Scientific/Detailed Comments: Referee comments in bold and author answer non-bold.

Review comments by Referee #1

In this manuscript the authors described assimilation of soil moisture observations into the land surface model CLM5. In general, the paper is well structured, described and written. I have several questions which are still unclear for me.

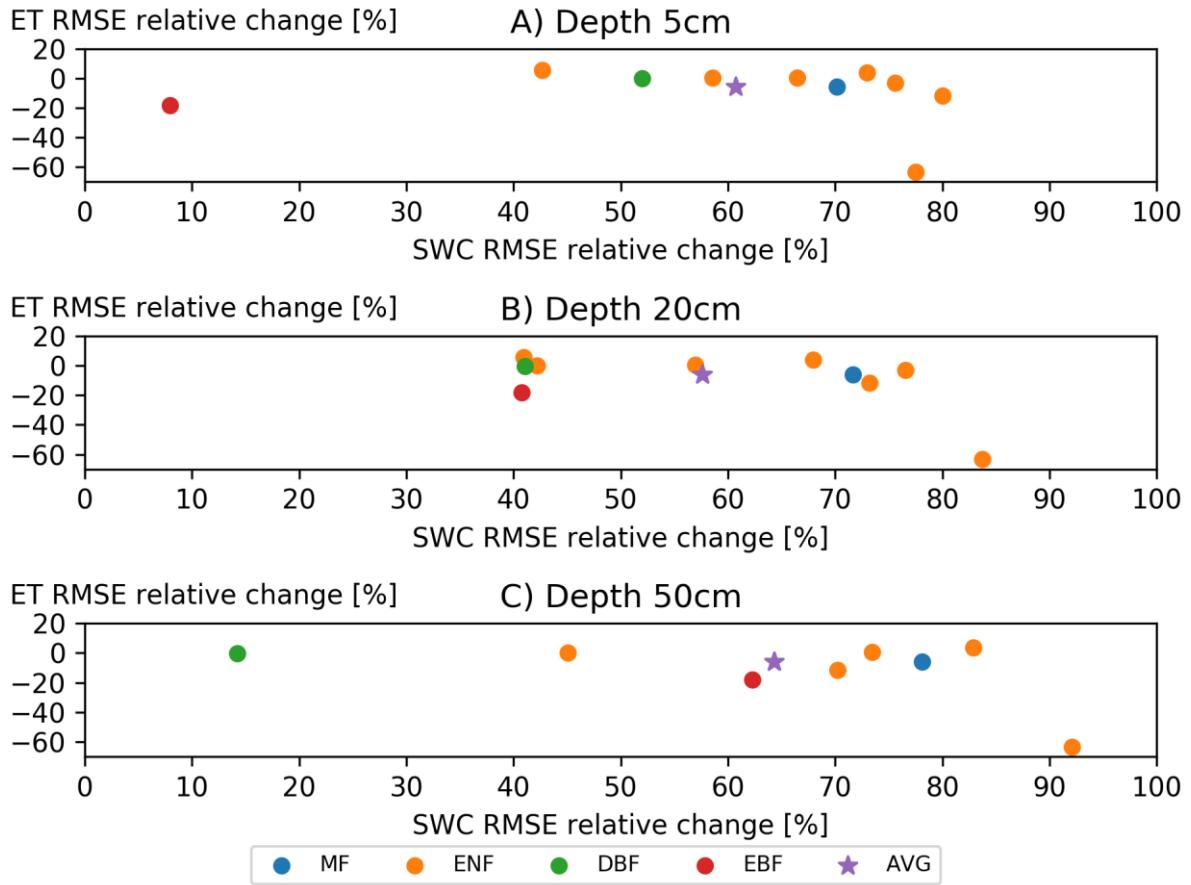
First, I don't see how the author's came to the conclusion “[the] results suggest that state-of-the-art LSM such as CLM5 still suffer from uncertainties in the representation of soil hydrological processes in forests, e.g. deep root water uptake, uncertainties in the representation of biological processes of tree transpiration”, without accountning for biases of the simulated leaf area for the sites. Running CLM5-BGC can lead to erroneous leaf area values, and is why CLM users often use CLM-SP (prescribed leaf area) to diagnose to what extent the simulation of leaf area is impacting your soil moisture and ET relationship. Have a look at Li et al., (2022) or Fox et al., (2022) as an example of how prescribing or assimilating observations of leaf area can effect the representation of carbon and water cycling.

If the simulated leaf area is incorrect in magnitude and timing it is unlikely that improving the soil water content through DA will improve ET. The authors do not account for this in the manuscript.

We agree that running CLM5-BGC can lead to erroneous LAI simulation results and that CLM-SP can be used to diagnose to what extent this uncertainty affects the simulation of soil moisture and ET. Therefore, we now also explore the difference between CLM-SP and CLM-BGC simulations and have included the corresponding results in the revised manuscript.

“This could be caused by the mismatch of simulated and actual LAI for these sites. To investigate this, we repeated the simulations using CLM5 with satellite-derived phenology (CLM5-SP). The results are shown in Fig. 9. For CLM5-SP we observe an average improvement in the RMSE of SWC between 57.6 % and 64.3 % and an average RMSE deterioration of 5.8 % for the ET estimation. These CLM5-SP simulations use the default datasets from CLM5 and without site specific calibration of the timing or magnitude of the seasonal phenology of LAI. Therefore, even for the CLM5-SP simulations, there is a mismatch between simulated and actual LAI. However, also for this case, there are sites with a large improvement in SWC estimation that show deterioration in the ET estimation.

Figure 5: Time series of the saturated soil hydraulic conductivity for each site in the DASP simulation. The grey line is the value at 5 cm depth, the blue line at 20 cm depth, and the green line at 50 cm depth.

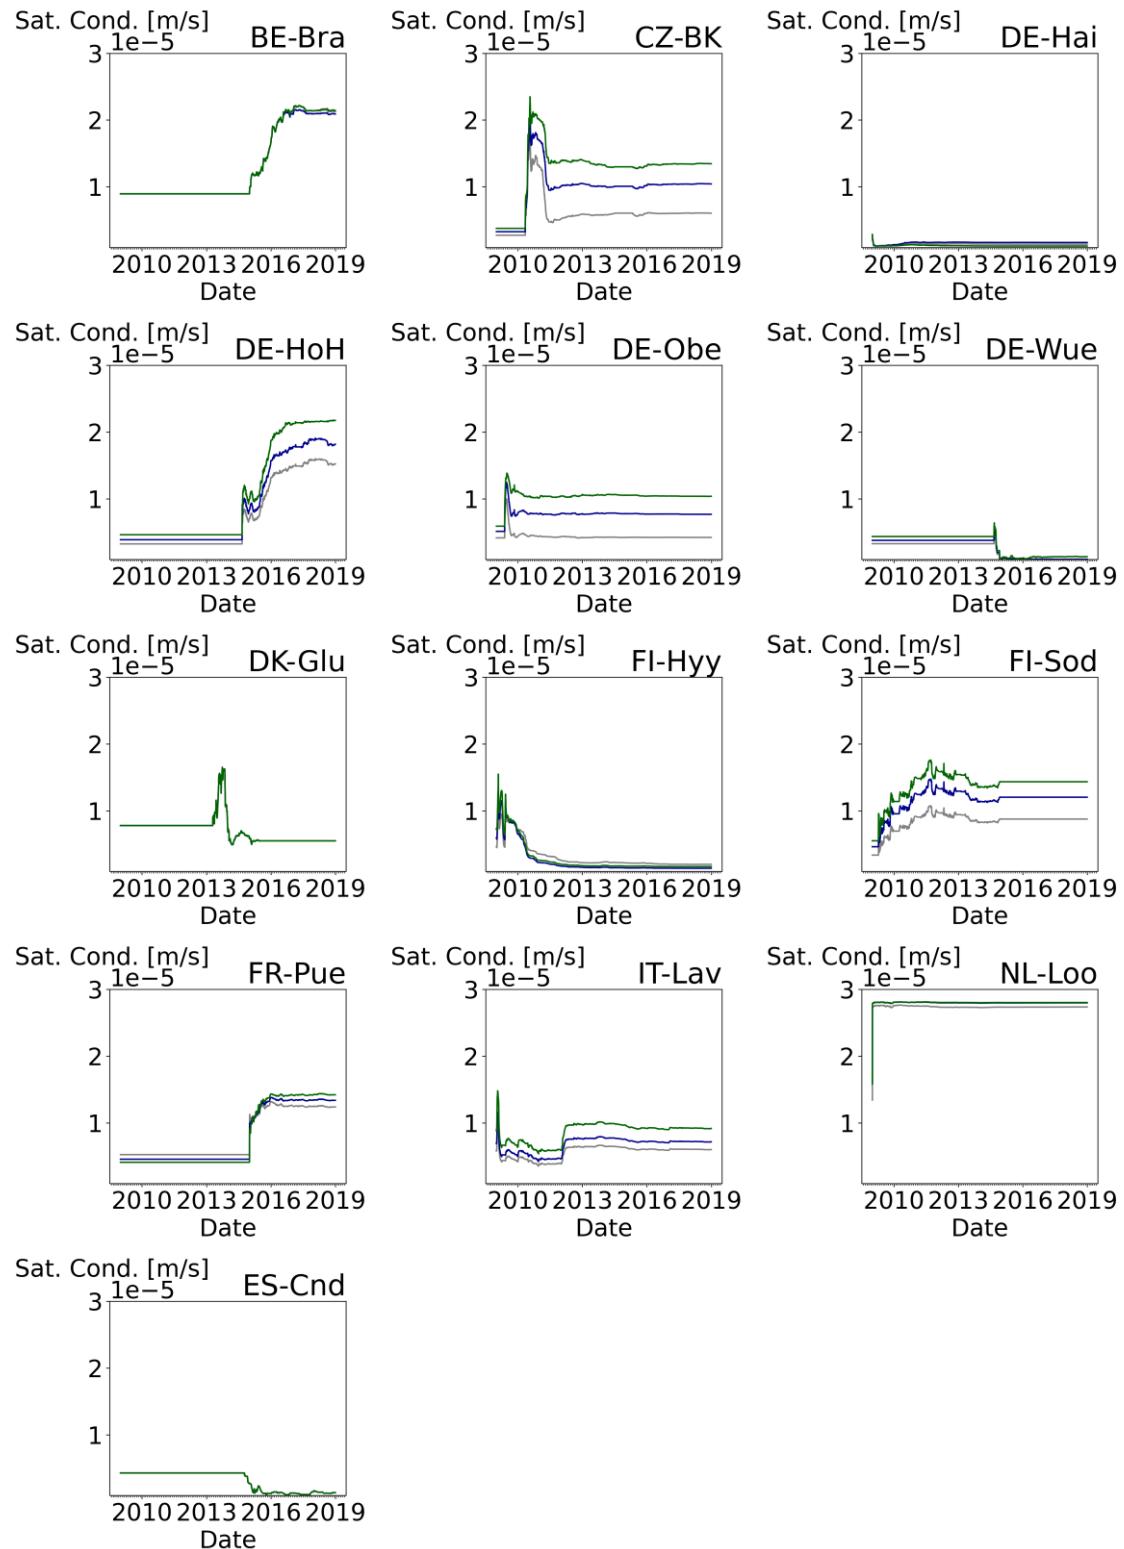
Finally, the authors never provide figures/tables of the influence of the DA on the parameter values. Do the parameter values converge to a new value, or are they temporally changing and random? Without this information it is impossible to assess why the parameter estimation had little influence on ET.

We agree that we did not provide enough information about the parameter updates, since we did not see it as a focus of this study. The parameters updated with DA do change when observations are assimilated and converge to new values. We included a new figure to show this.

“Figure 5 shows time series of the estimated saturated soil hydraulic conductivity for each of the sites and the three observation layer depths. The DASP scenario results in parameter changes when the first observations are available but converge over the time of the simulation to a new value. The corresponding time series for the other soil hydraulic parameters can be found in the appendix (Figures A8, A9, and A10). The sand, clay, and organic matter fraction and thus the soil hydraulic parameters can vary with depth but as shown in Fig. 5 the DA updates to the parameters affect the different layers similarly.”

Figure 2: Scatter plots of observed soil water content at 20 cm depth at nine study sites versus OL and DAS simulated soil water content. The points represent daily averages for the days observation data are available. Green points are OL and blue points are DAS results.

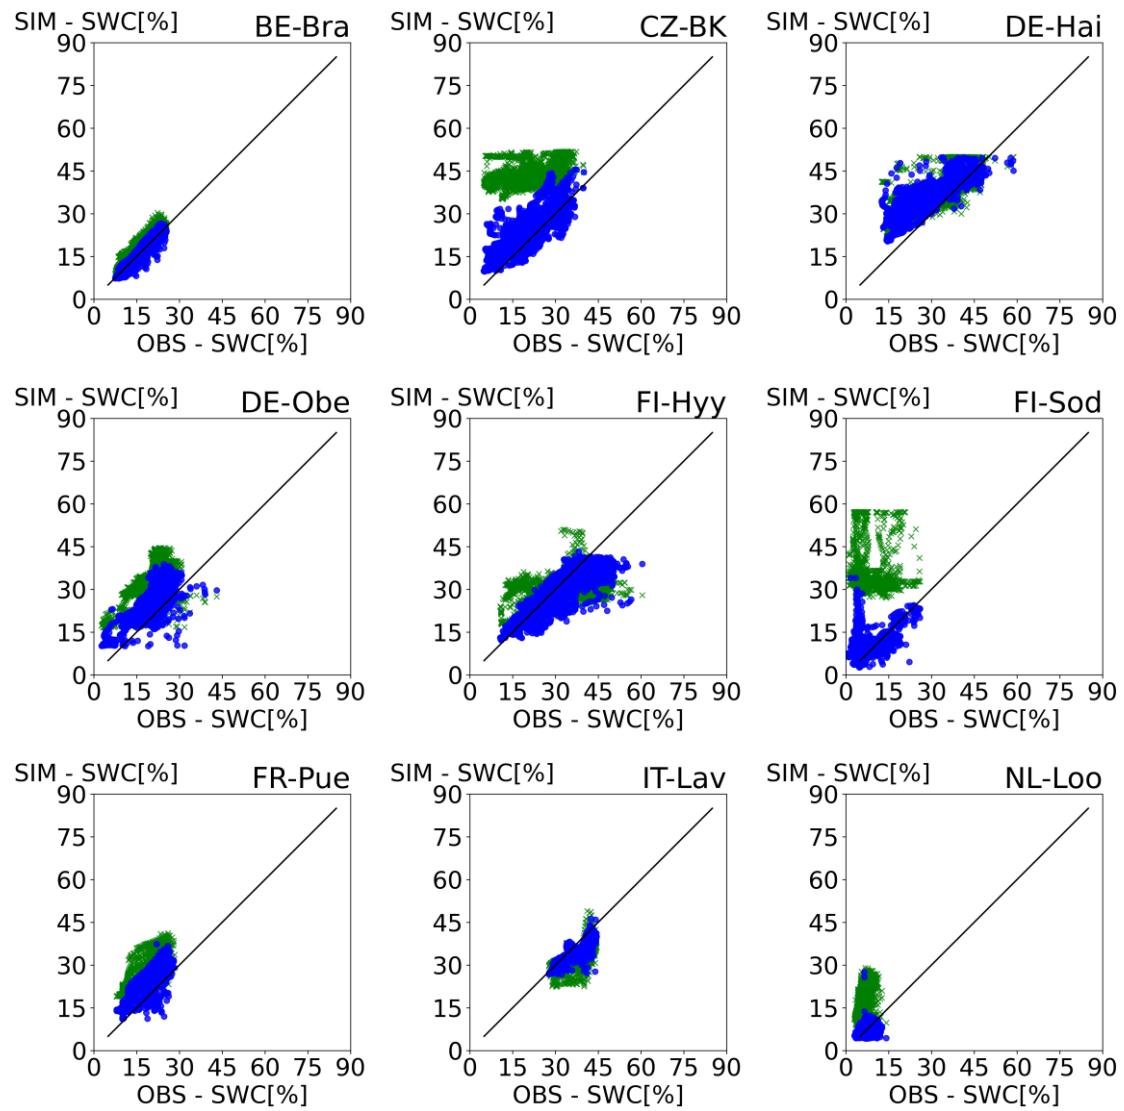
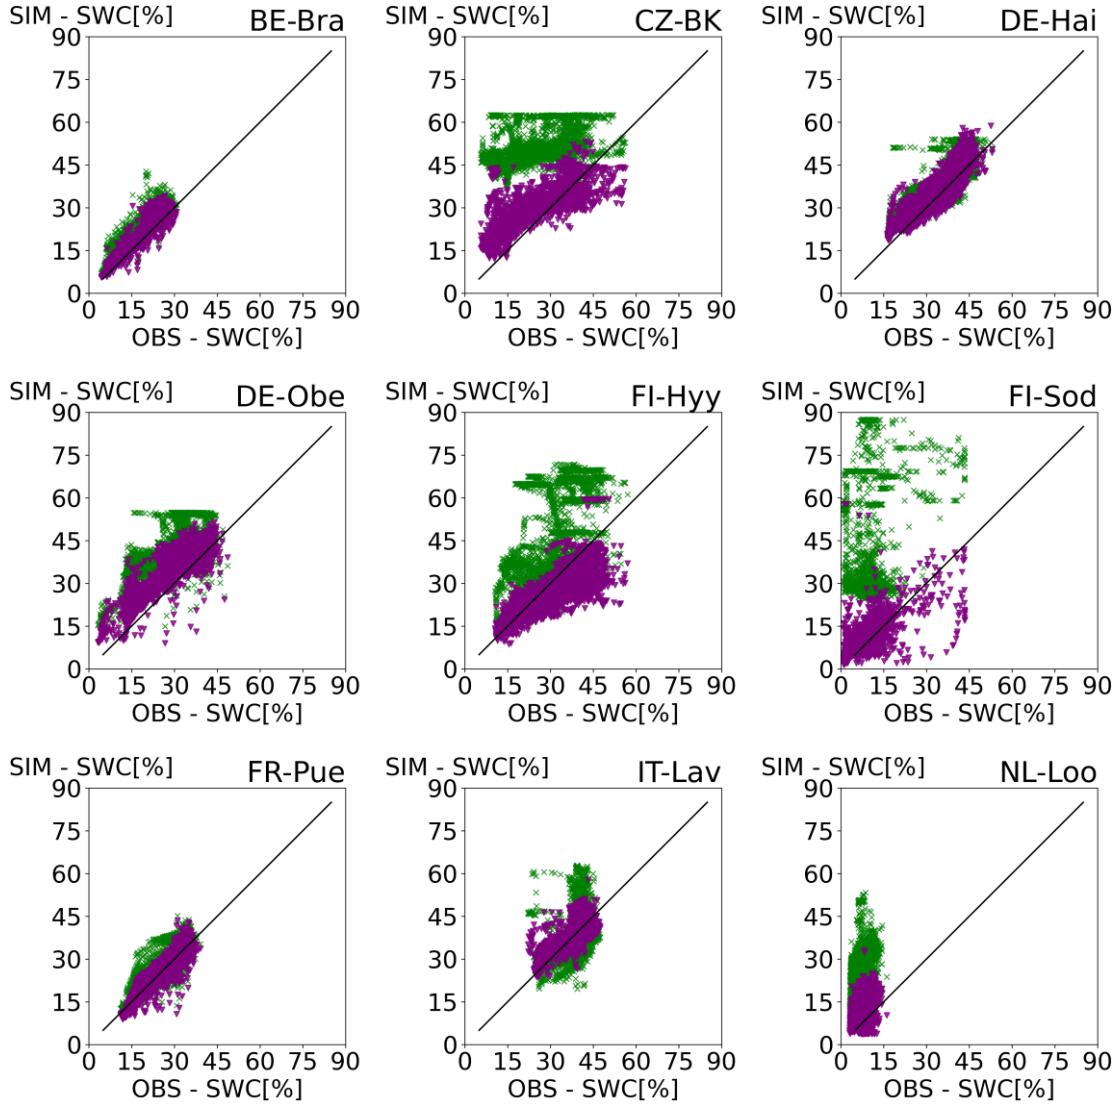
Figures 2-4: You could combine these plots to present a better comparison between OL-DAS and OL-DASP.

We combined the Figures 2-4.

“Figures 2 and 3 show the results of the soil water content simulations at 20 cm depth of the OL, DAS and DASP simulations compared to the soil water content observed at the nine sites. Figure 2 compares the OL and DAS results and Fig. 3 compares the OL and DASP results. The corresponding scatter diagrams for the depths 5, 20, and 50 cm can be found in the appendix (Figures A1 - A7). Overall, the results show expected improvements by data assimilation of observed soil water content. For the OL simulations, Fig. 2 shows particularly large RMSE values for CZ-BK, DE-Obe, FI-Sod and NL-Loo. Fig. 2 also illustrates the improved performance achieved by DASP, with a RMSE reduction from $29.3 \text{ cm}^3/\text{cm}^3$ to $6.25 \text{ cm}^3/\text{cm}^3$ and a MBE reduction from $28.06 \text{ cm}^3/\text{cm}^3$ to $-2.94 \text{ cm}^3/\text{cm}^3$ for FI-Sod. Parameter updating, as shown in Fig. 3, further improves the simulation results, but the improvement from DAS to DASP is significantly less than from OL to DAS.”

Figure 14: Seasonality of simulated LAI (DASP) for each of the sites.

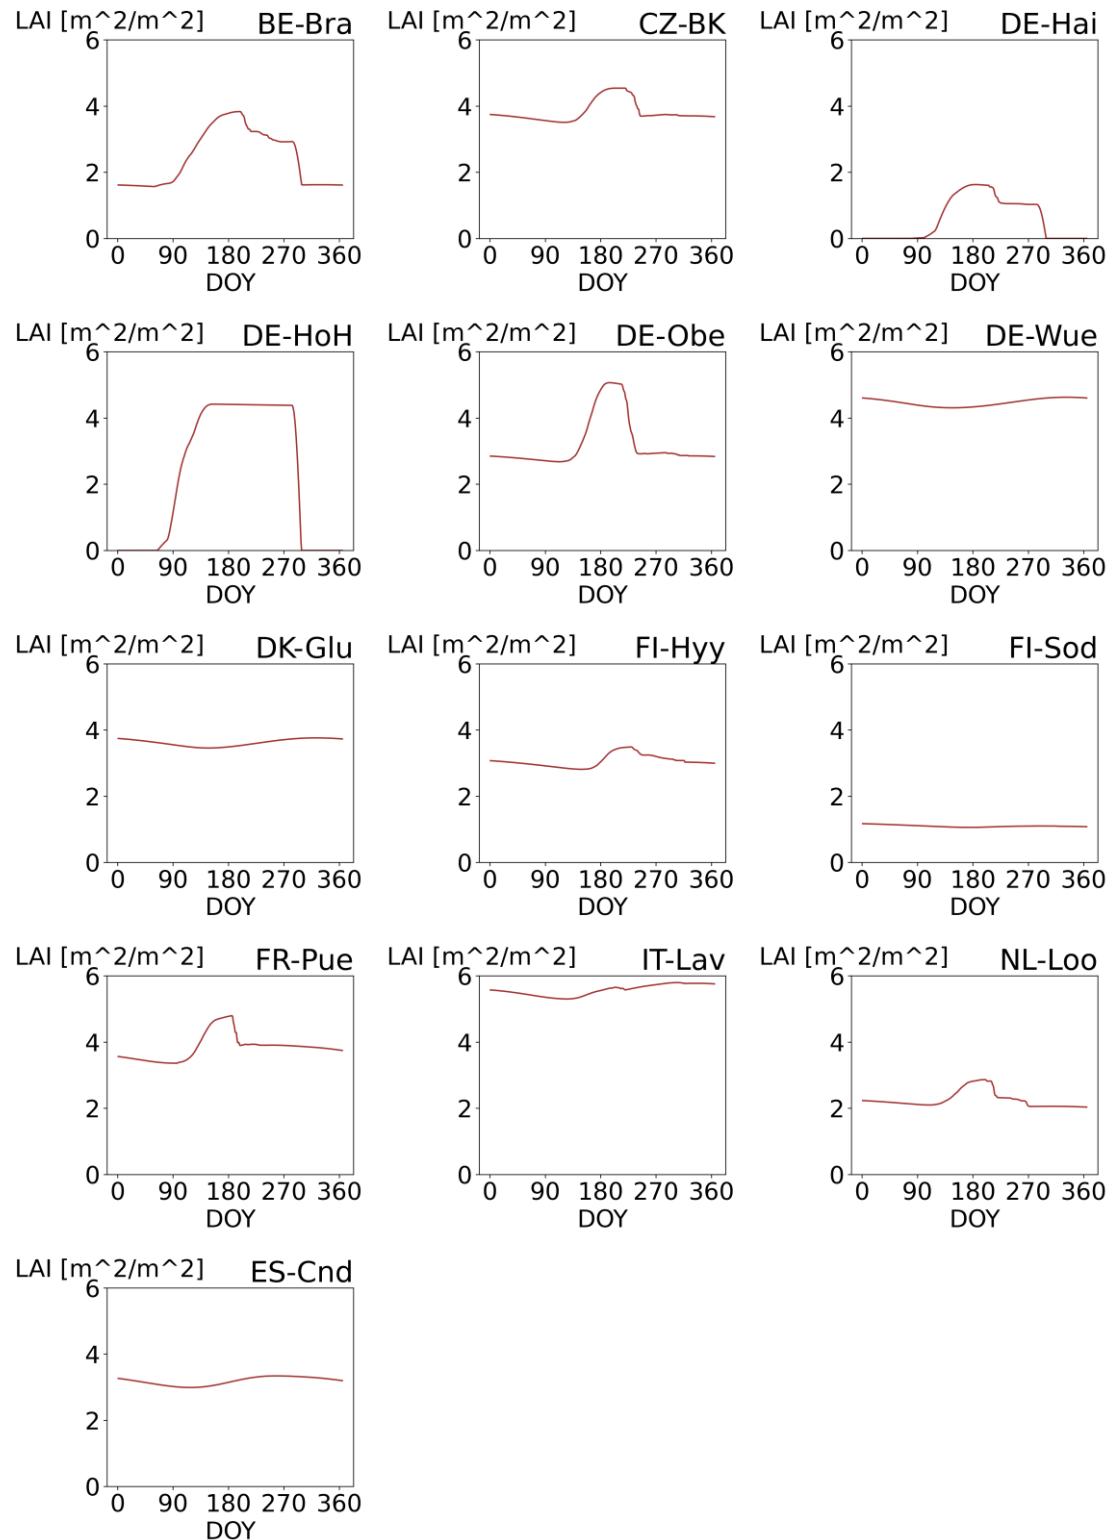
Figure 11: This figure seems very critical, given the potential mismatch between observed and simulated LAI, and the potential impact that has on the soil water content vs. ET relationship. I feel like you also need to present the average season cycle of LAI for all these sites, because the the annual average is not enough. CLM has trouble simulating the timing of seasonal phenology of LAI especially for evergreen forested sites (not just magnitude). Would help to simulate a CLM5-BGC and CLM5-SP simulation here, where LAI is prescribed, or assimilate LAI observations directly for your experiment.

We added a figure with the seasonal LAI cycle for each site and include a comparison with simulations where LAI is prescribed as mentioned earlier. In addition, we will work with LAI assimilation in future studies.

“Figure 14 shows the LAI for each site averaged over all the simulated years. Sites with the same PFT show clear differences in the yearly LAI cycle. ”
